P/2016/00440  
Received  
21/03/2016

Project  
 Pennycroft Lane  
 Uttoxeter

Title  
 Detailed Engineering Layout  
 Sheet 1 of 2

Scale	1:200 @ A1	Drawn	LH
Date	November 2014	Checked	SCM
File	14102/dwgs/civils	Drawing	14102 / 101 A

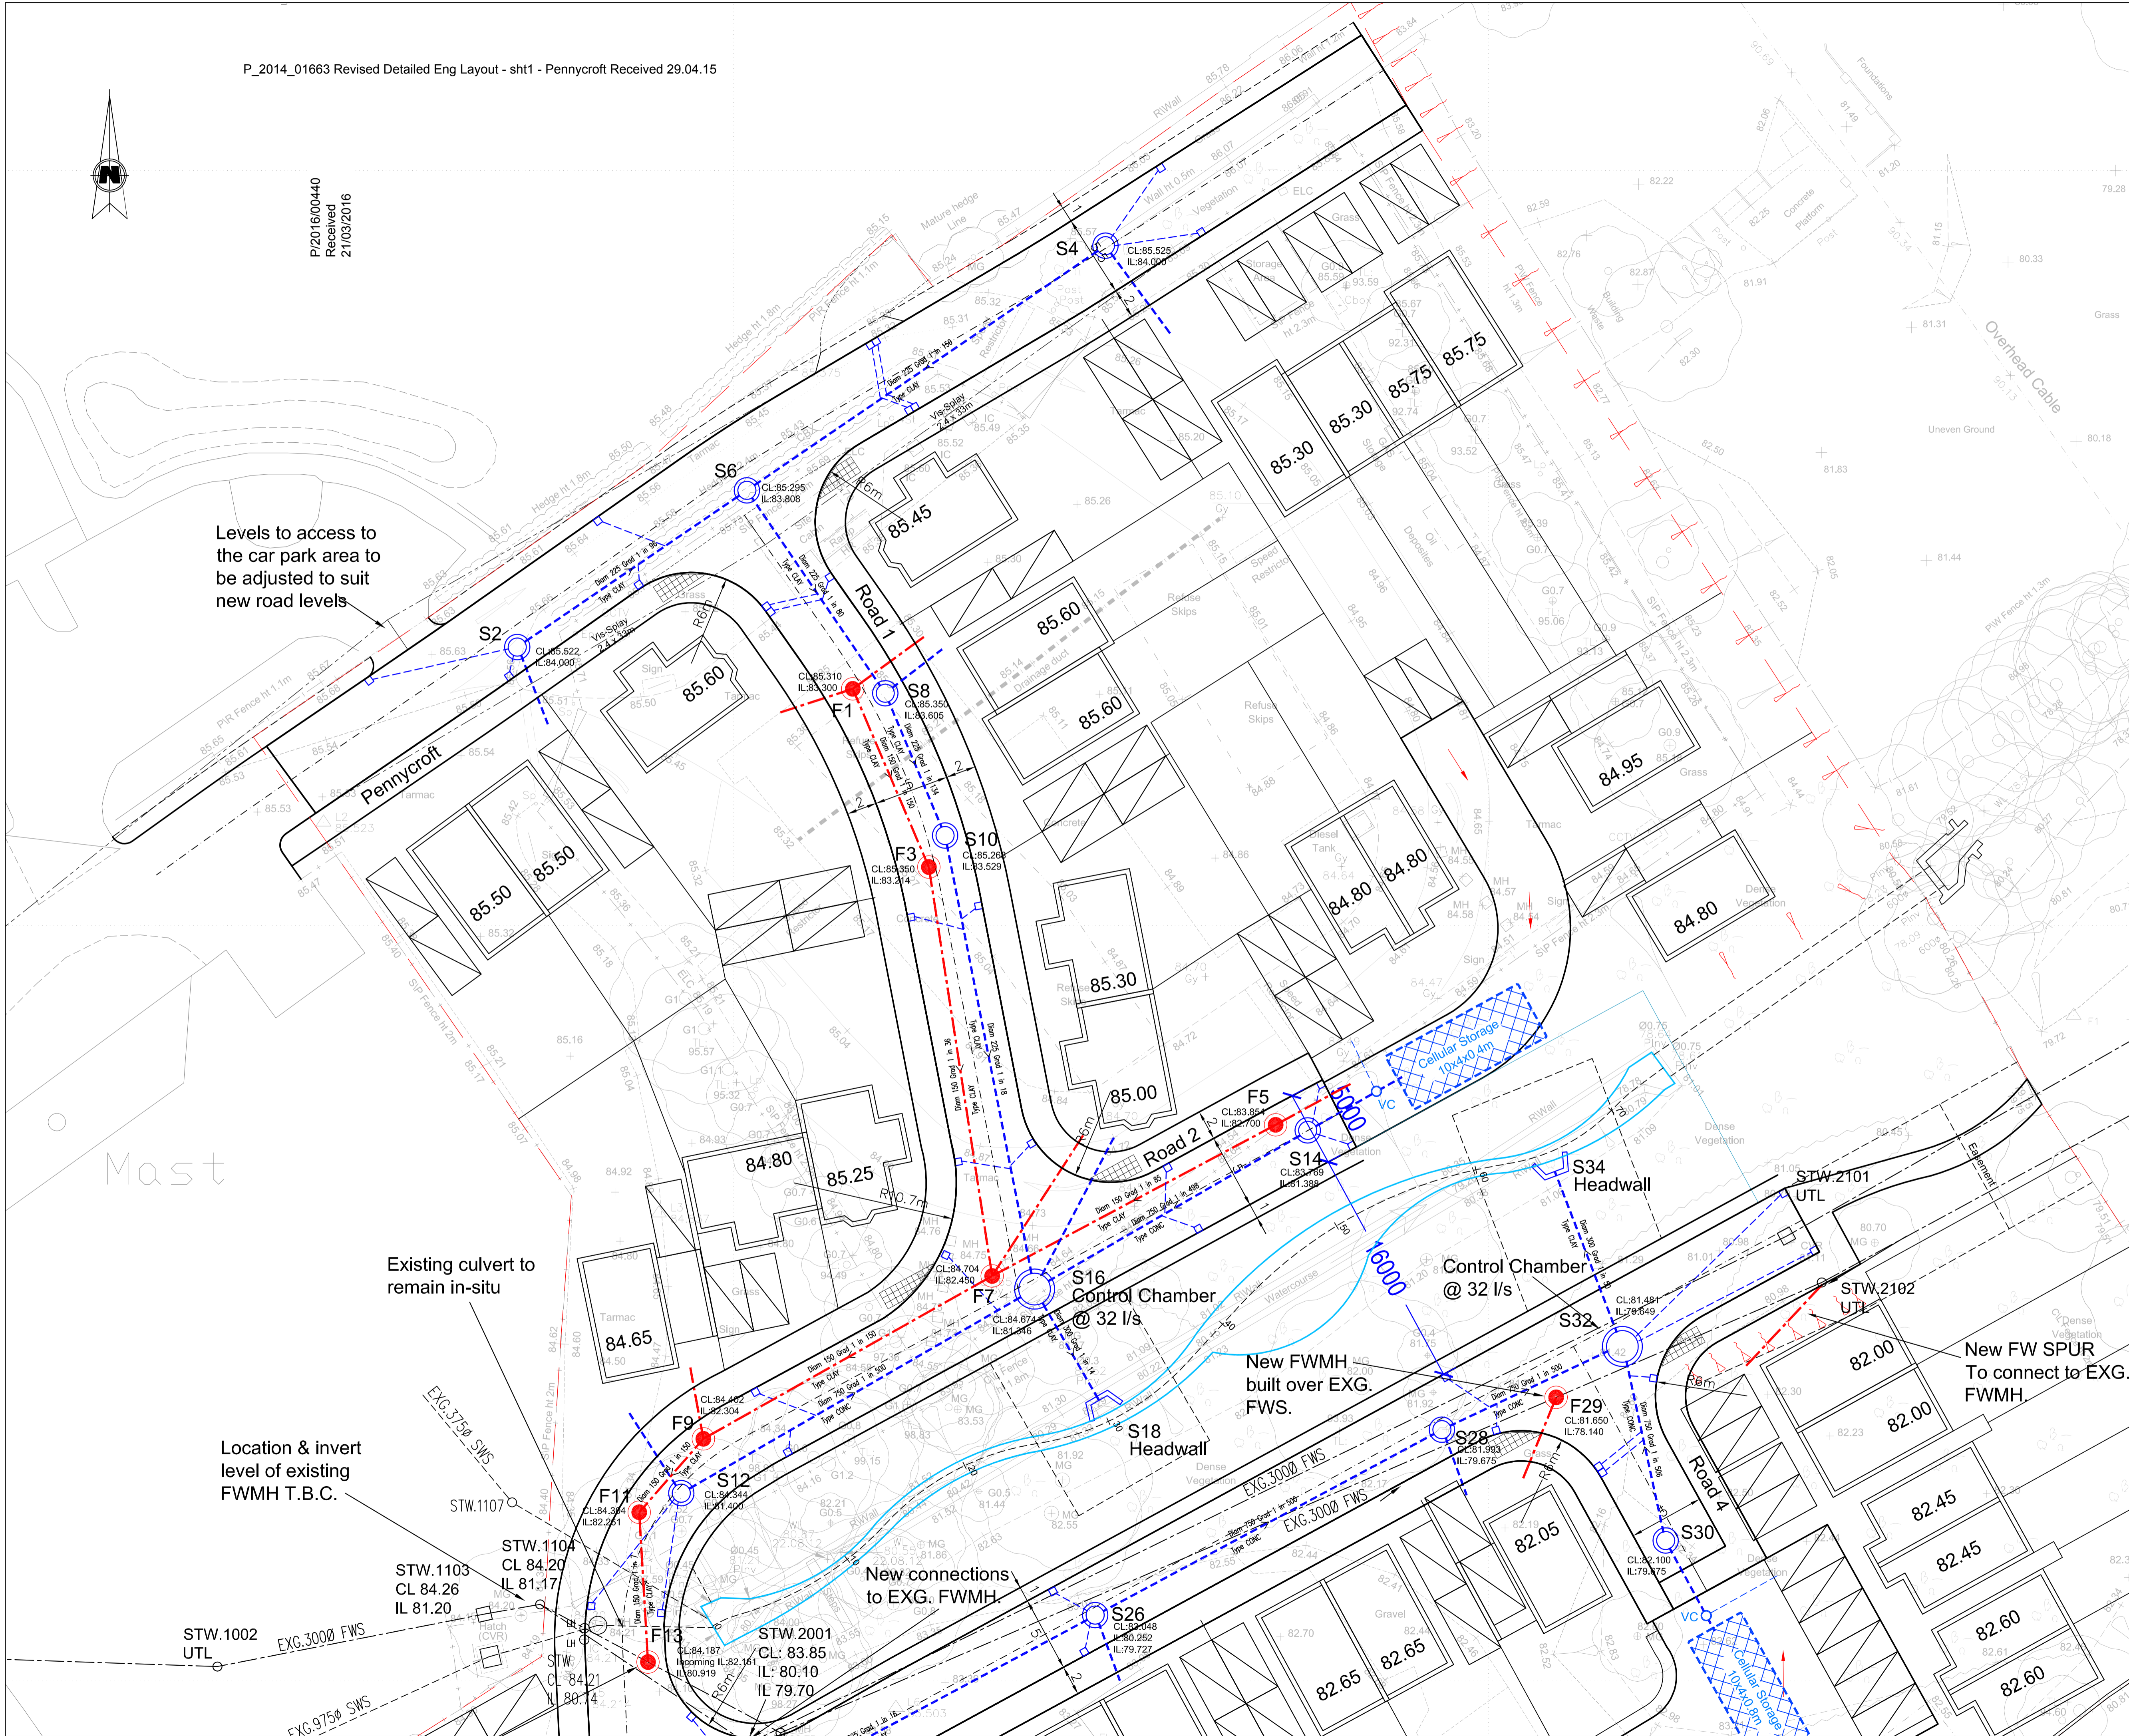
Levels to access to  
the car park area to  
be adjusted to suit  
new road levels
